DRAINAGE – Condition 3

Flamsteed, Lake Lane, Barnham, West Sussex, PO22 0AD

Further to the refuse submission to discharge Condition 3, outlined below is a response to the queries raised. Requests made by the LA;

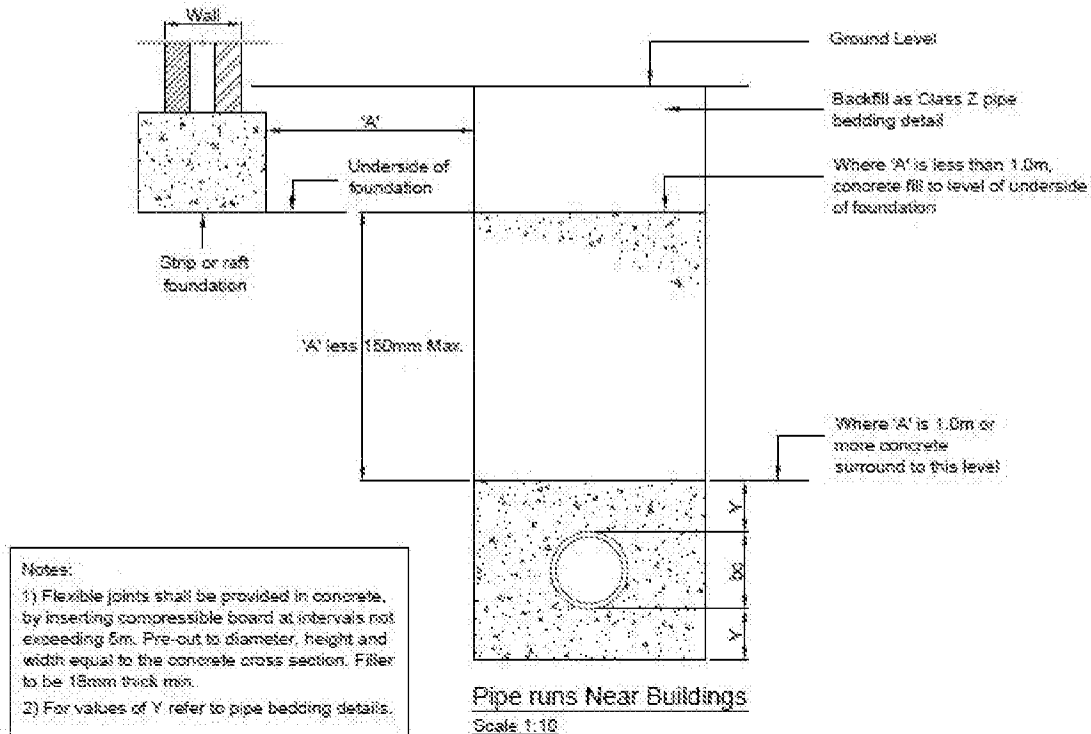
1. Calculations provided within the original Discharge of Conditions application. Areas shown on Plans included with application. Existing non-permeable 76.27m² and proposed total non-permeable area 118m²
2. The 1 in 100 year event should allow for + 40%, this is on page 5 of the original calculations
3. Below is a section through the type manhole/inspection chamber to be used

Sited in domestic gardens

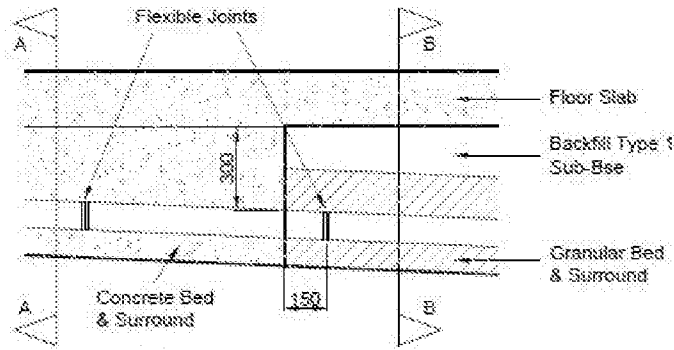
4. Detail below shows details of where drains pass near walls

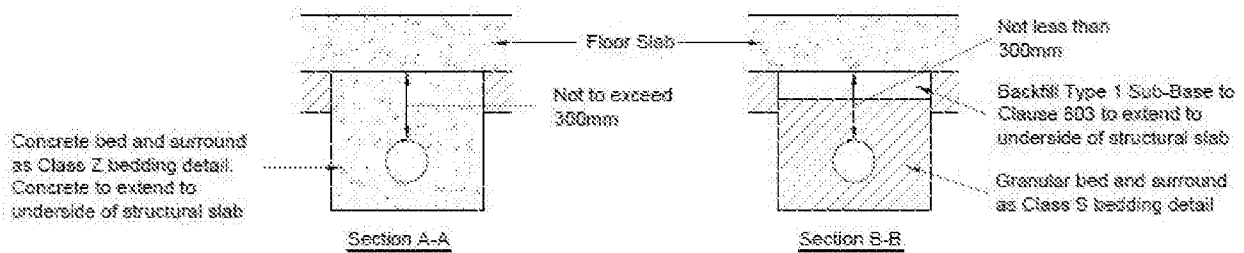
5. Details below of drain runs under floor slab

1. Concrete bed and surround shall be provided as section A-A where distance between underside of slab and pipe soffit is less than or equal to 300mm.
2. Where pipes with flexible joints are used the concrete protection shall be interrupted over it's full cross section at each joint by a shaped compressible filler.
3. If pipes are surrounded in concrete, the joints shall be protected from the ingress of concrete by wrapping them with two coats of mastic bandage tape.
